SERVICE BULLETIN SB99.10F

Machines/Models: SL20

PURPOSE: To enhance the performance of the electrical circuitry.

OPERATION REQUIRED: Replace existing Controller (#101129-011) and add one .33 OHM Resistor Pack (Black, #101129-021), and one 1 OHM Resistor Pack (Yellow, #101129-020) and install Wiring Harness (#101228-000).

Figure 1

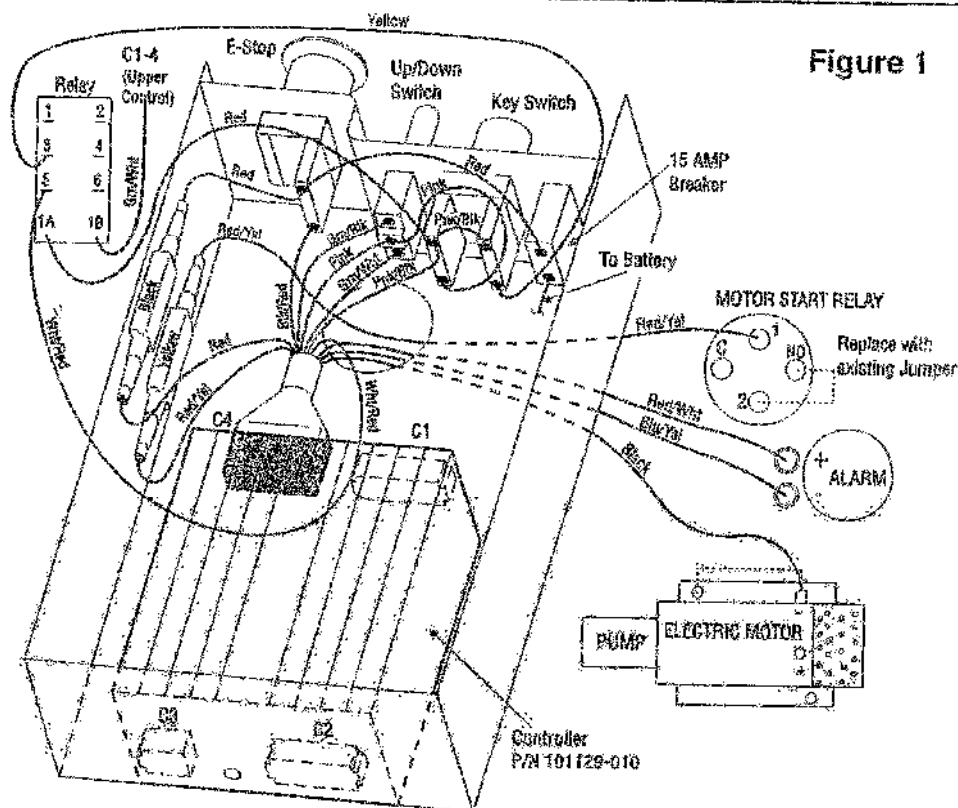
8. Install Wiring Harness (#101228-000) as illustrated in Figure 3 according to the drawing in Figure 1.
9. Install the 1 OHM Resistor Pack (Yellow, #101129-020) and the .33 OHM Resistor Pack (Black, #101129-021) using the Cable Mounts (#013283-002) and 3" Tie wraps as shown in Figure 4.

Figure 2

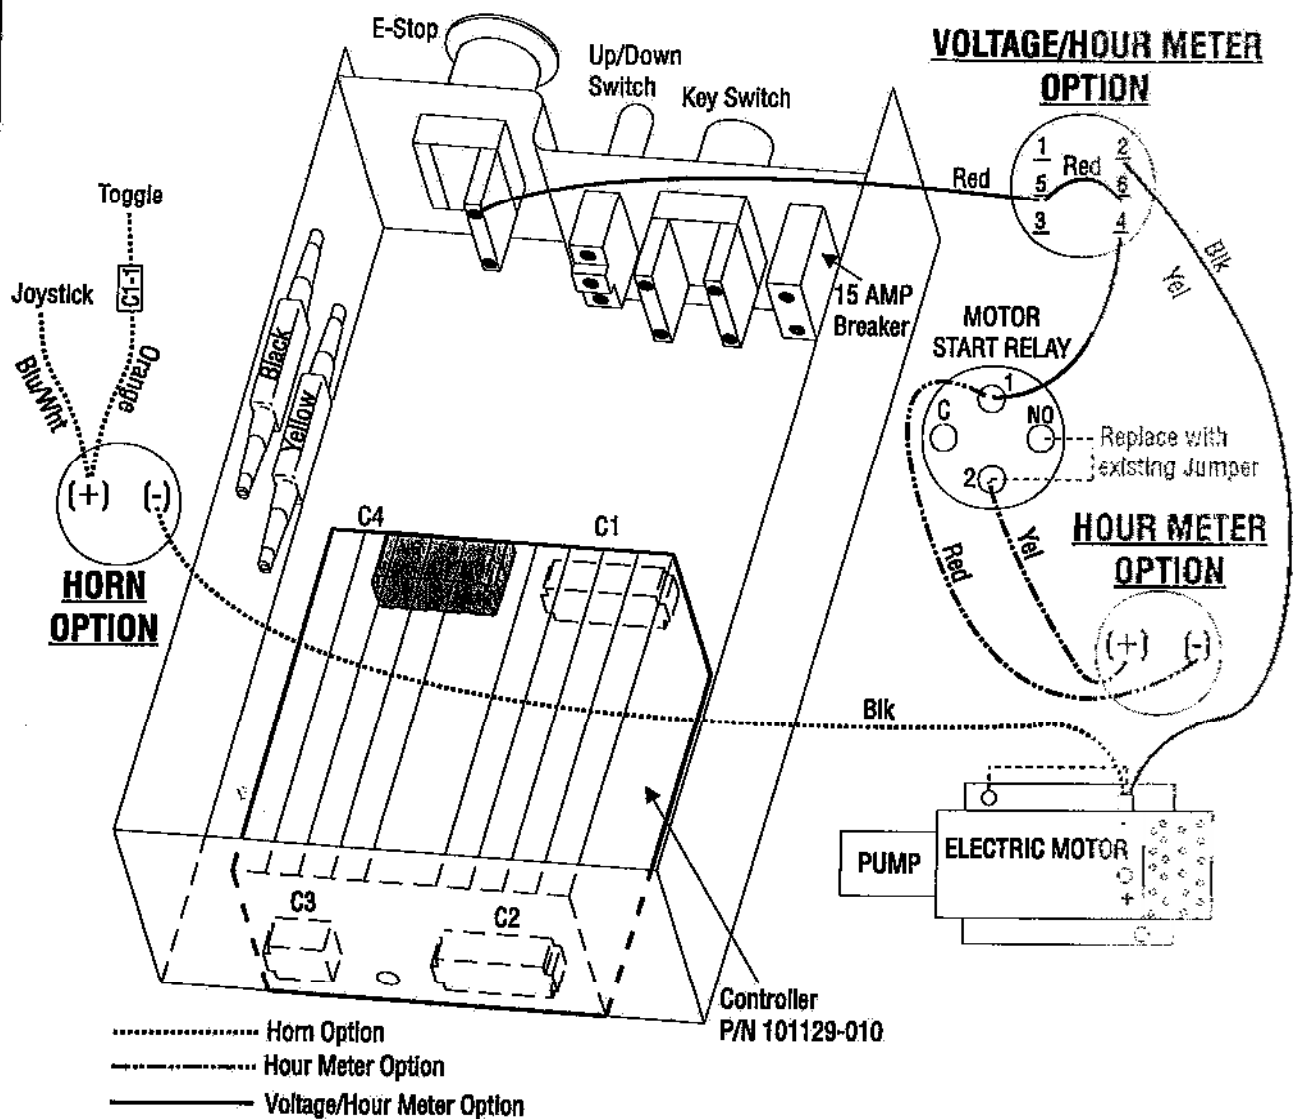
10. If options are installed on the machine, wire them as shown in Figure 2.
11. Install the new 12 Volt Joystick Controller (#101129-010) securing it with the two remaining 10-24 screws and nuts.
